EASA Safety Information Bulletin

SIB No.: 2014-34
Issued: 23 December 2014

Subject: **Possible Exceedance of Engine Temperature Limits of BRP-Powertrain Rotax 912 and 914 Engines**

Ref. Publication: BRP Powertrain Service Bulletin SB-912-066 and SB-914-047 (single document) dated 08 December 2014, or later approved revisions.

Picture 1 – CHT versus CT measurement

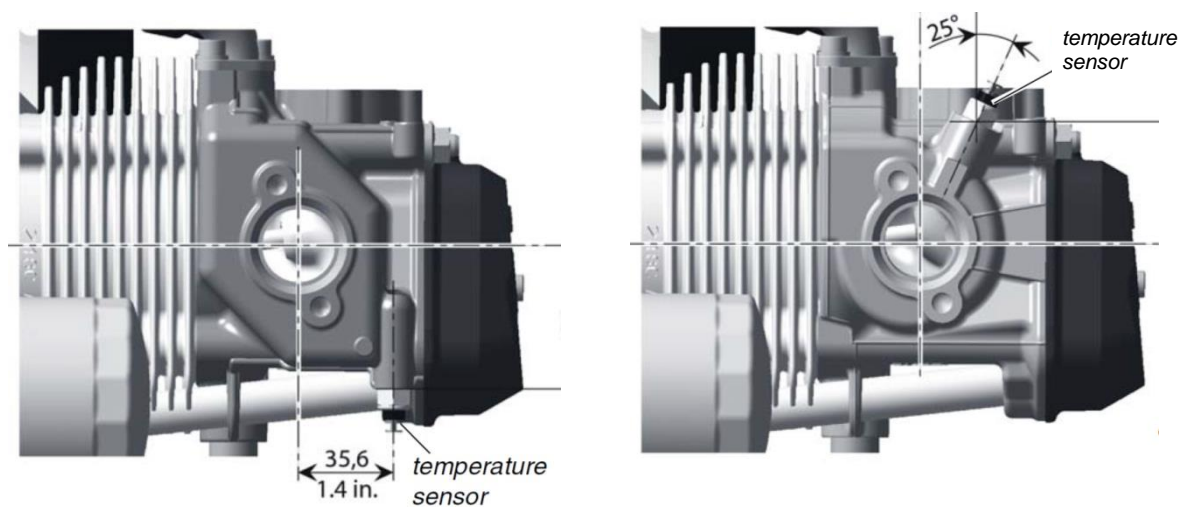
The reported conditions are the result of an insufficiently communicated engine design change which altered the engine/aircraft interfaces by substituting the previous cylinder head temperature (CHT) measurement (limit temperature 135°C/150°C) with a coolant temperature (CT) measurement (limit temperature 120°C).

This design change is currently not identified by the engine model designation or the engine P/N but only through the cylinder head P/N and the position of the temperature sensor:

CHT measurement → temperature sensor points downward
 CT measurement → temperature sensor points upward

Refer to [Picture 1](#) in Annex 1 of this SIB.

Old cylinder head design, CHT measurement

New cylinder head design, CT measurement
